RE: BE/15/26/PL - Land East of Heath Place, Bersted, West Sussex, PO22 9SL: Environment Agency Position

We are writing in response to the initial EA comments on planning reference BE/15/26/PL, dated 02 April 2026.

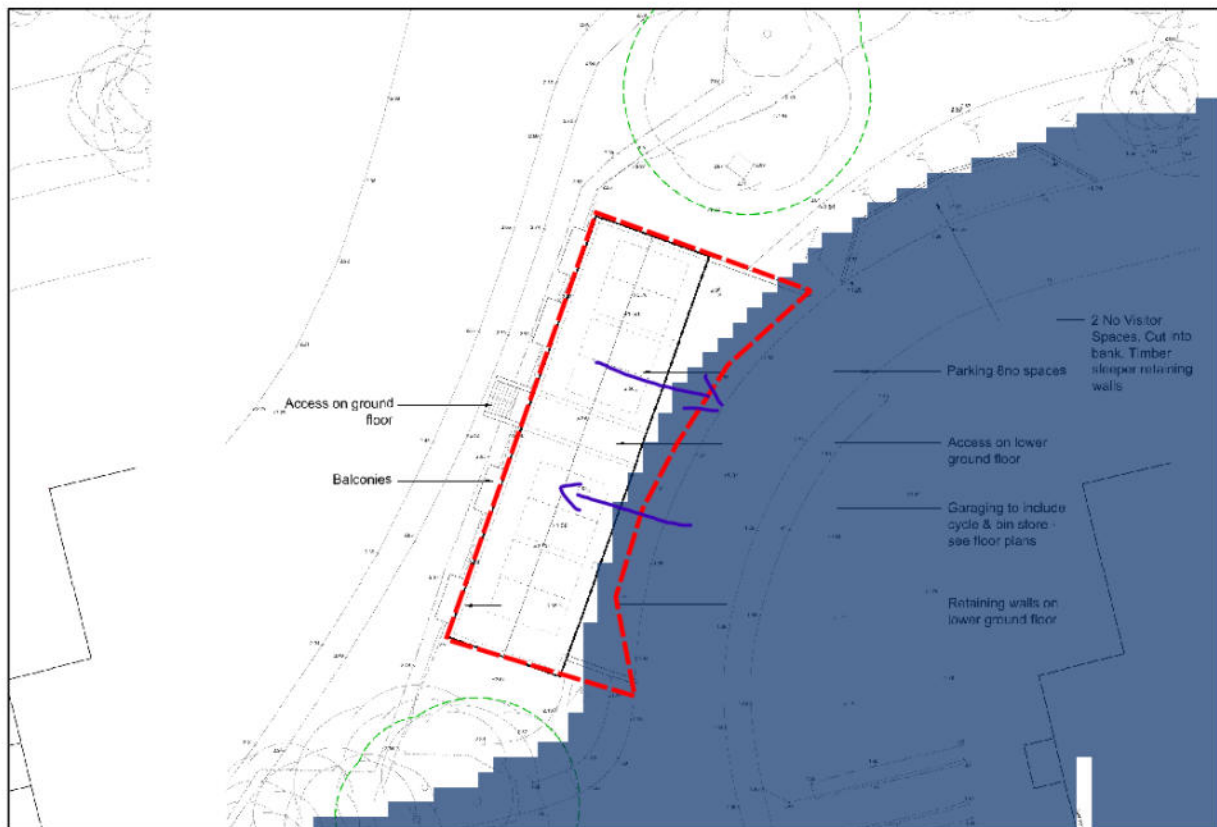
The FRA does not therefore adequately assess whether the development will increase flood risk elsewhere. In particular, the FRA fails to:

- *take the impacts of climate change into account:*
 - *Flood risk mitigation measures to address flood risk for the lifetime of the development included in the design are inadequate because they will not make the development resilient to the flood levels for the 0.1% AEP fluvial flood event. Consequently, the development proposes inadequate flood storage compensation.*

The use of under croft car parking at ground floor level has been proposed at other sites within the Aldingbourne Rife catchment area. Our local position is that, while in some cases they allow water to flow freely and will therefore not be classed as voids, they do not remove the need for floodplain compensation entirely. Therefore, loss of floodplain area to accommodate large supporting pillars/posts for these structures, should still be adequately compensated.

- The site is located on the edge of the floodplain and therefore there is no overland flow or flow pathway through the building. Water will rise on Heath Place and enter the site through the open front then recede the same way, as indicated by the purple arrows on the image below.

- The front of the building is largely open apart from two supporting pillars (totalling 0.45m²) and the stairwell.
- The car parking area is to be lowered to have a FFL similar to that of Heath Place (1.40m AOD) to allow car access. Currently, the land levels in this area are circa. 2.50m AOD.
- Therefore, as highlighted within the FRA already, levels are being lowered from outside the floodplain into the 1000 year floodplain – **which will increase floodplain capacity.**

- The car parking areas either side of the stairwell total 108m² and 90m². Lowering these two areas to 1.40m AOD will provide an additional 66.96m³ and 55.80m³ floodplain storage, respectively. (108x0.62=66.96. 90x0.62=55.80)
- The stairwell totals 23m² and the two supporting pillars in the front total 0.45m². Accounting for these within the floodplain calcs means 14.26m³ and 0.279m³ of flood water would be displaced.
- Overall, there will be an increase in floodplain capacity of approximately 108.221m³ during the 1000 year flood event.
- Given the significant increase in floodplain capacity, there is no additional requirement to provide additional compensatory flood storage on site.
